Southampton to London Pipeline Project

Responses to ExA's Further Written Questions -
People and Communities (PC)

Application Document: 8.41

**Southampton to London Pipeline Project
Response to the Examining Authority's Further Written Questions – People
and Communities (PC)**

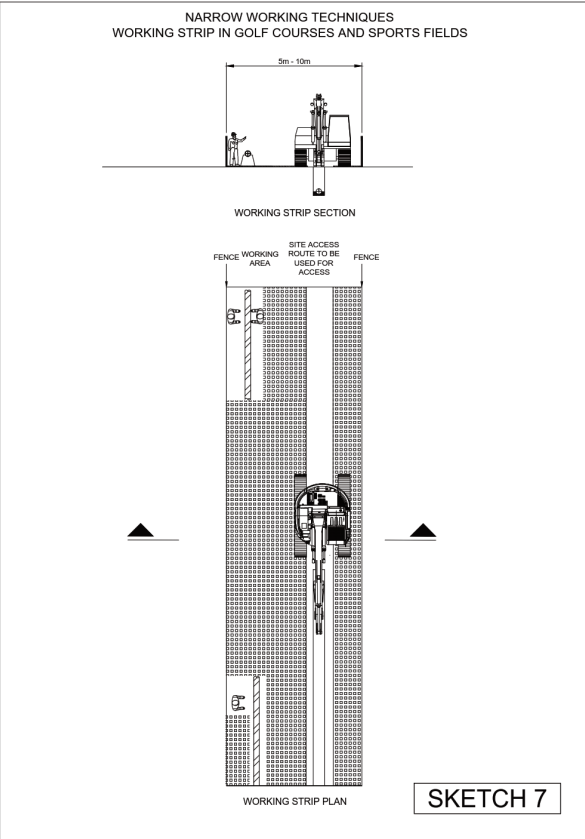
ExQ2	Question:	Applicant response to Question:
	<p>Review the locations where the Applicant has suggested the use of Echo fencing as noise mitigation and provide with explanation any other locations where such mitigation would be needed.</p>	
<p>PC.2.2</p>	<p>The Statement of Reason [AS-010a] refers to the fact that the proposed temporary construction compounds would not be connected to facilities and as a result would need to use a generator.</p> <p>i) Signpost or provide information on the generator including its noise emittance levels and hours of use; effects on receptors and mitigation if required.</p>	<p>1.1 In response to i), commitment G24 of the Code of Construction Practice (CoCP) (Document Reference 6.4, Appendix 16.1(3)) requires: <i>“In the absence of a mains electricity supply, super silent pack generators would be used as an alternative power supply. A generator shall be considered ‘super silent’ if it meets the following criteria:</i></p> <ul style="list-style-type: none"> • <i>has a maximum noise output of 69 dB(A) at 7m;</i> • <i>is fitted with a silencer in the diesel combustion exhaust system; and</i> • <i>includes a layer of barrier material within the casing of the generator to reduce noise breakout.”</i> <p>1.2 Commitment G24 has been revised at Deadline 4 to ensure that the generators at construction compounds comply with these requirements. It is secured through DCO Requirement 5 (CoCP). Also included within the Outline CEMP.</p> <p>1.3 The level of 69 dB(A) at 7m is equivalent to the source noise level assumed in the noise assessment. Therefore, the effects on receptors are those described in Revision 2.0 of Appendix 13.3 Noise and Vibration Technical Note Addendum submitted at Deadline 4 (Document Reference 8.14 (2))</p> <p>1.4 In response to ii), the generators would operate during the 'normal working hours', which are assumed to be between 08:00 and 18:00 on weekdays and Saturdays as set out in Requirement</p>

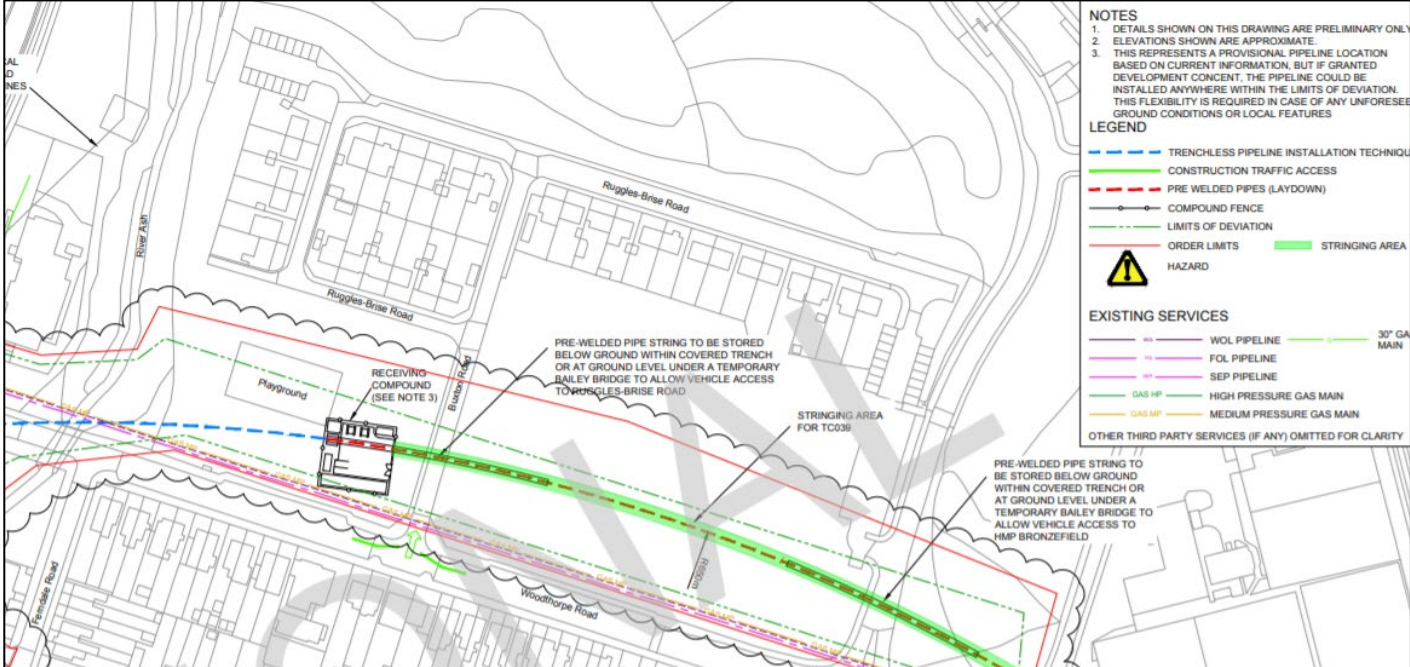
ExQ2	Question:	Applicant response to Question:
	<p>ii) How would this be secured in the dDCO [REP3-006].</p>	<p>14 of the draft DCO (Document Reference 3.1 (5)), and during the set up or shut down period should, for example, lighting, be required for safety reasons.</p>
<p>PC.2.3</p>	<p>For the Applicant: Respond to the concerns raised by Rushmoor Borough Council [REP3-041] that incorrect thresholds have been used with particular reference to Nash Close and if the incorrect thresholds have been used, provide an updated assessment and details of how this would affect the conclusions of that assessment.</p> <p>For Rushmoor Borough Council: Provide a response to the Applicant's response to Action Point 20 from the ISH on</p>	<p>1.1 The Applicant does not agree that the incorrect thresholds were used. This was an unsubstantiated claim made by Rushmoor Borough Council. The adopted criteria utilised by the Applicant are informed by the guidance provided in the Department of Environment advisory leaflet AL72 Noise control on building sites (Department of Environment, 1976). The categories described in AL72 are as follows:</p> <ul style="list-style-type: none"> • 70 dB(A) in rural, suburban and urban areas away from main road traffic and industrial noise; and • 75 dB(A) in urban areas near main roads and heavy industrial areas. <p>1.2 These categories and thresholds have their origins in the Wilson Committee Report on noise (Wilson Committee on the Problem of Noise, 1963), and are based on achieving a level of 55 dB(A) indoors, which was considered by the Wilson Committee to avoid interference with speech. The external level of 70 dB(A) was derived from the 55 dB(A) internal level plus a 15 dB difference between indoor and outdoor levels for closed but ill-fitting windows. The level of 75 dB(A) was recommended near main roads and heavy industrial areas as existing noise levels in these areas were considered likely to exceed 70 dB(A).</p> <p>1.3 Window design and specification is very different now to 1963, with the majority of properties now having well-fitting thermal double glazing as a minimum. The World Health Organization's Environmental Noise Guidelines for the European Region (WHO Regional Office for Europe, 2018) as well as former Planning Policy Guidance PPG24 (Department of the Environment, 1994) suggest that a difference between indoor and outdoor levels of 25 dB should be assumed for rooms with closed windows.</p>

ExQ2	Question:	Applicant response to Question:
	<p>Wednesday 4 December 2019 [REP3-015].</p>	<p>1.4 In this context, the adoption of a significance threshold of 75 dB(A) for urban locations is considered to achieve the intent of the Wilson Committee, regardless of the proximity to main roads and heavy industrial areas and was correctly used in the Applicant’s assessment.</p> <p>1.5 In response to the representations made at the Issue Specific Hearing on Environmental Matters, the Applicant has revised the classification of receptors to ensure a more precautionary approach to the assessment. The threshold of significance for noise during installation of 70 dB(A) has now been adopted for all residential receptors.</p> <p>1.6 The updated assessment conclusions are presented in Revision 2.0 of Appendix 13.3 Noise and Vibration Technical Note Addendum, submitted at Deadline 4 (Document Reference 8.14(2)). The assessment concludes that that the revised threshold of significance would be exceeded at properties in 34 streets (including Nash Close), rather than the 10 streets covered by the original commitment. Acoustic barriers are therefore now included at additional locations, and this is reflected by the revisions to commitment G107 made at Deadline 4 - secured through DCO Requirement 6 (CEMP) included within the Outline CEMP. This was amended in the CoCP at Deadline 2 (REP2-010) and at Deadline 4 following discussions at the Issue Specific Hearings.</p>
